ORDINARY COUNCIL - 9 MARCH 2023 Attachments

10.1. DA0744/2023 - 10 ST GEORGES SQUARE, LAUNCESTON -
RESIDENTIAL - DEMOLITION OF EXISTING DWELLING AND
CONSTRUCTION OF A NEW DWELLING3
10.1.1. DA0744/2022 - 10 St Georges Square, East Launceston - Planning
Scheme Assessment3

TITLE: DA 0744/2022 - 10 St Georges Square East Launceston Residential -

FILE NO: DA0744/2022

Proposed southern side elevation

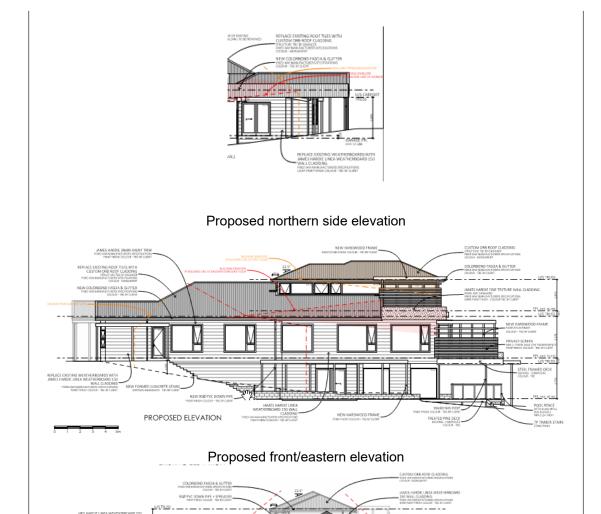
The southern side boundary does not meet (b).

The performance criteria must be addressed.
